Addendum

Global technical regulation No. 6

SAFETY GLAZING MATERIALS FOR MOTOR VEHICLES
AND MOTOR VEHICLE EQUIPEMENT

(Established in the Global Registry on 12 March 2008)

Figure 2: Prescribed points of impact for uniformly toughened glass panes

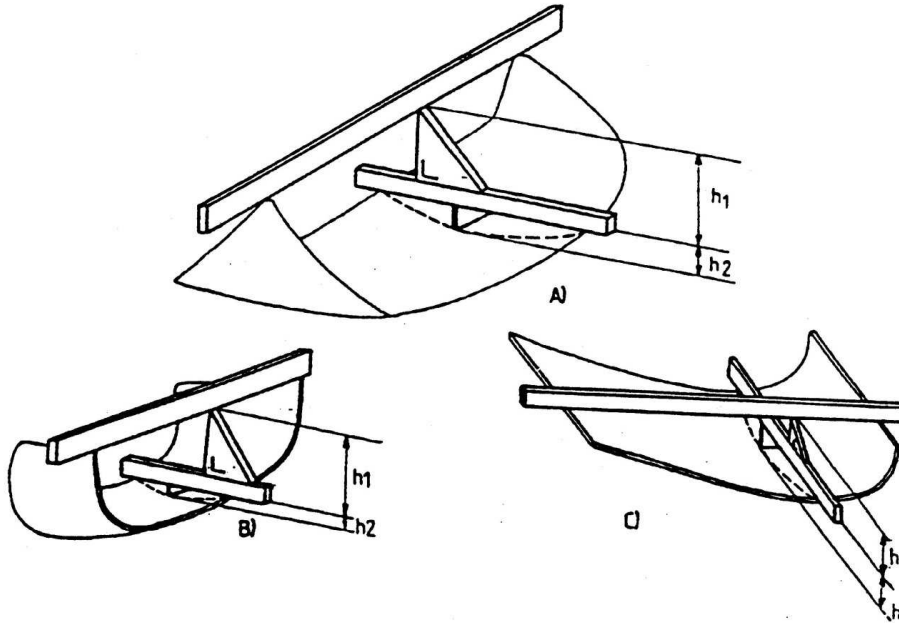
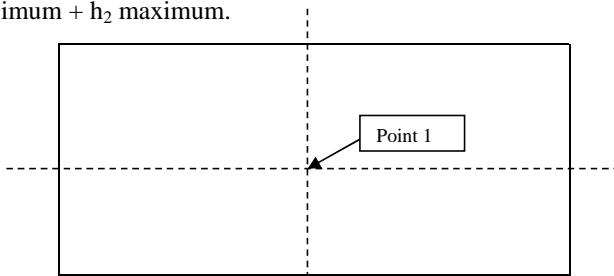
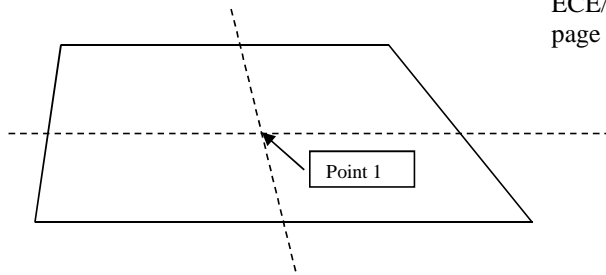
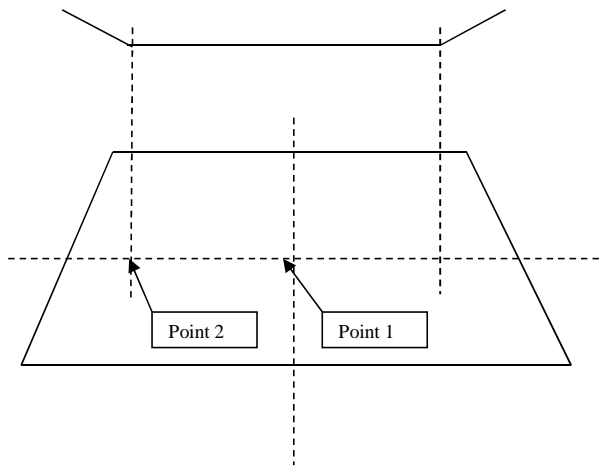
Kommentar [m16]: New Section 7.2: Change Proposal by Industry (OICA/JAMA / ALLIANCE) presented in 4th meeting IWG PSG to split test specification in case of overhead glazing

Kommentar [m17]: New Section 7.2: Change Proposal by KOREA presented in 4th meeting IWG PSG to split test specification in case of overhead glazing
